ZBA 14-01

444 S. Westmore-Meyers Rd.
(06-09-308-034)

A variation to allow a five foot (5') tall fence (of decorative materials and a minimum of 75% open space) in a front yard where four feet (4') is the maximum allowed.

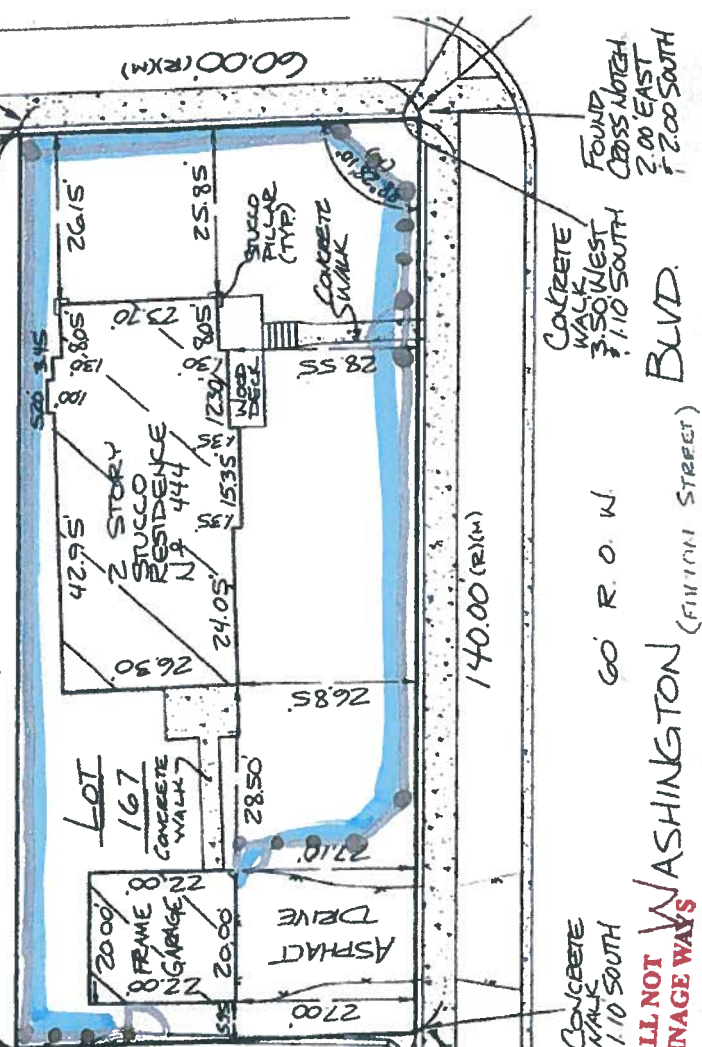
The fence is less than one foot (1') away from the sidewalk, indicating that it may have been installed in the right-of-way (Village property).

- a) Provide proof that the fence is entirely on their property via an updated Plat of Survey; or
- b) Relocate the fence so that it is at least one foot (1') from the sidewalk as indicated on the existing plat.
